Northeast
Utilities System

Docket No. 50-336
B16062

Millstone Nuclear Power Station, Unit No. 2
Reporting of Changes to, and Errors in,
Emergency Core Cooling System Models or Applications

Request for Additional Information

FIGURE 1

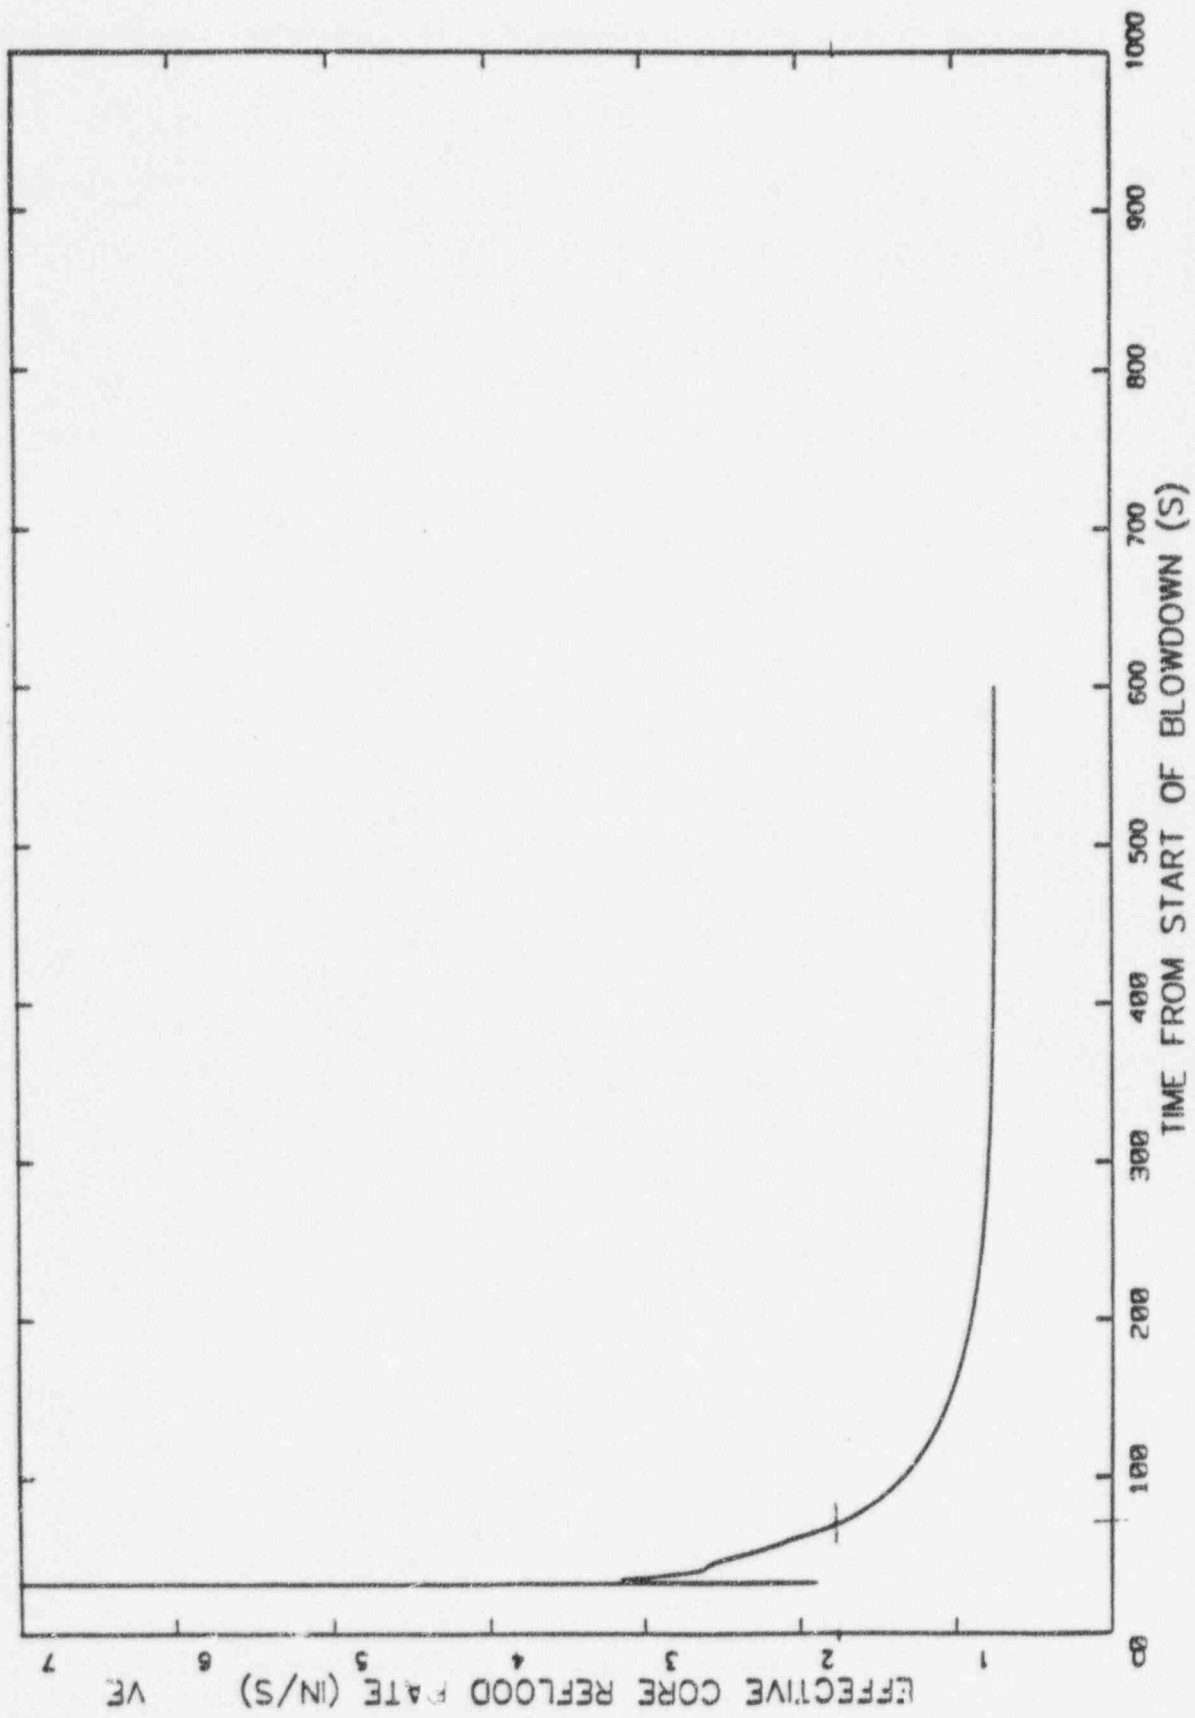
- (2) Reflood rate as a function of time
 - (3) Core collapsed level as a function of time

In response to items a. and b., SPC reanalyzed the Millstone Unit No. 2 LBLOCA using an interim modification to the FCTF reflood heat transfer correlations as described above. In response to item c., the maximum linear heat generation rate used in the reanalysis was 15.1 kw/ft. Core inlet subcooling is 132.1°F. This value of subcooling is used in the FCTF correlations throughout the reflood period. The remaining requested information is provided in Attachment 1 in the form of plots for the limiting LBLOCA.

FIGURE 3

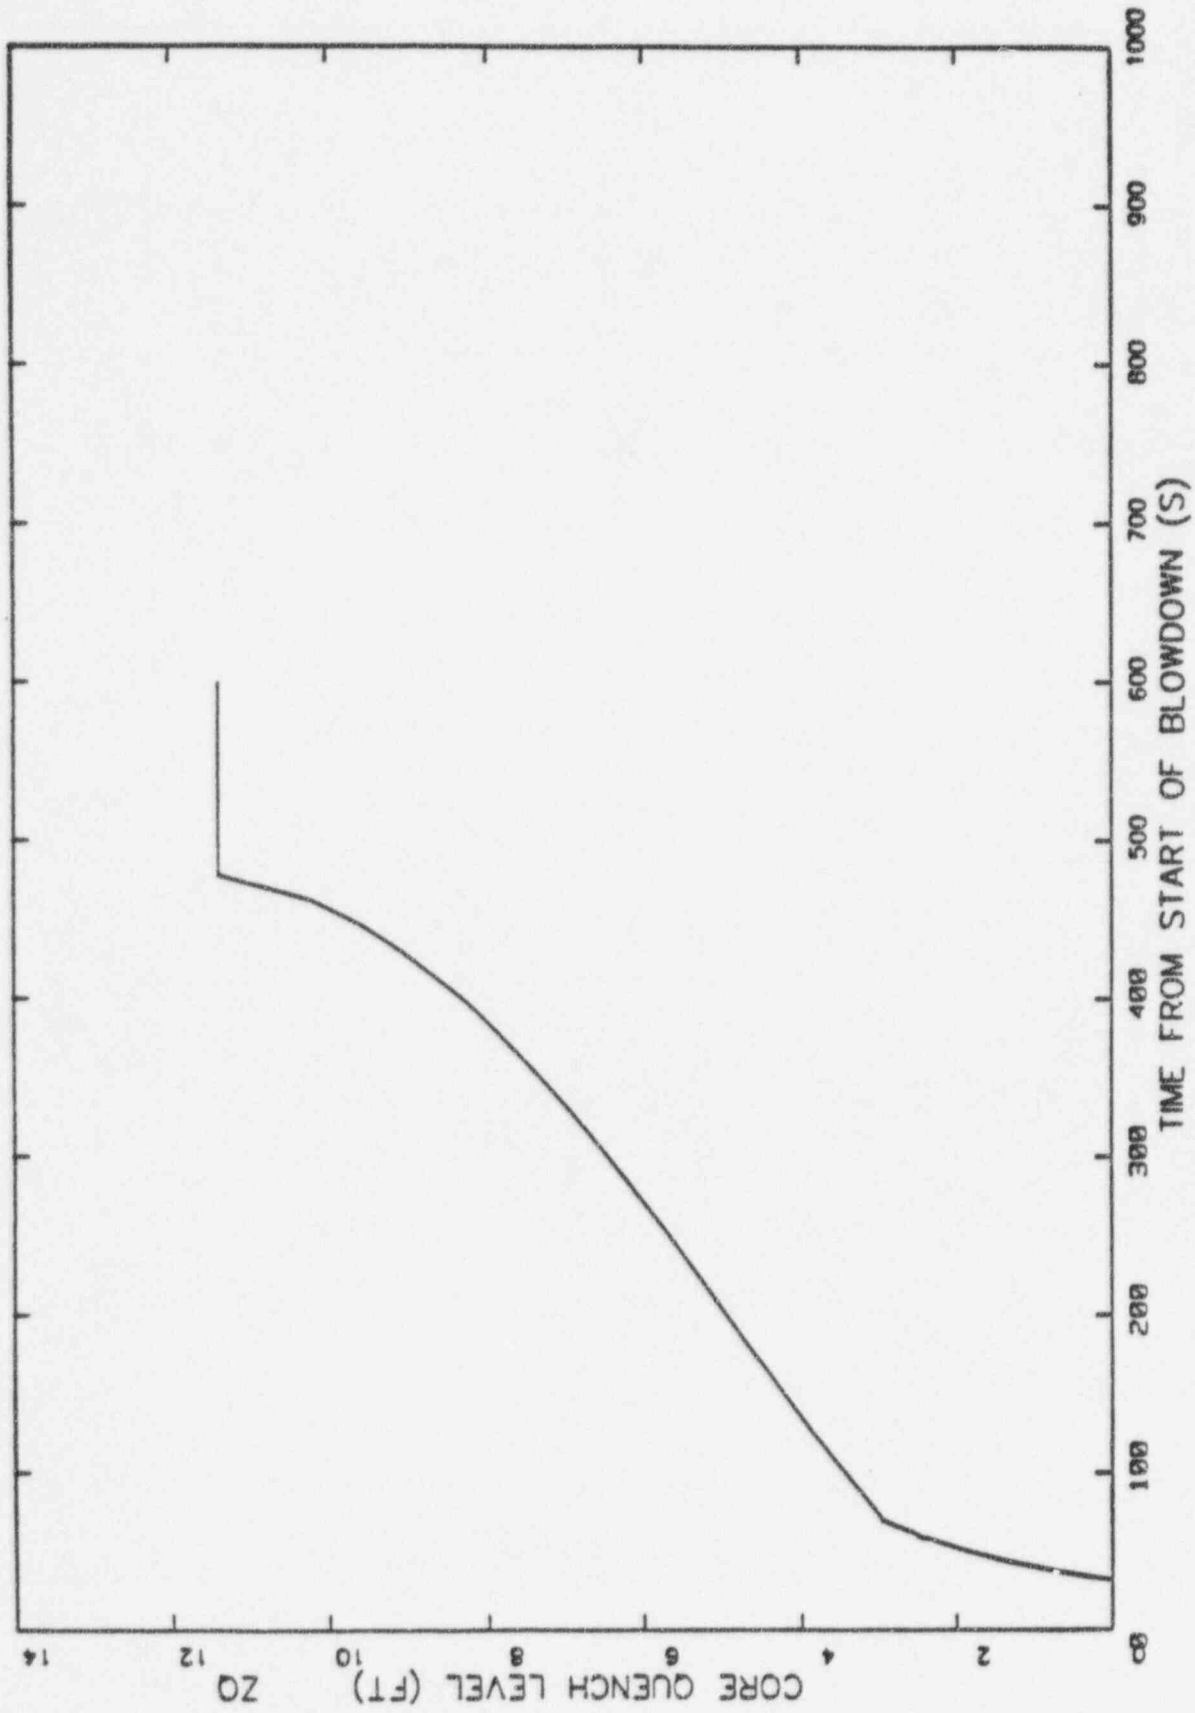
- (4) Quench time as a function of core height
- (5) Core pressure as a function of time
- (6) Core subcooling as a function of time
- (7) Heat transfer coefficient for PCT location as a function of time
- (8) Clad temperature for PCT location as a function of time
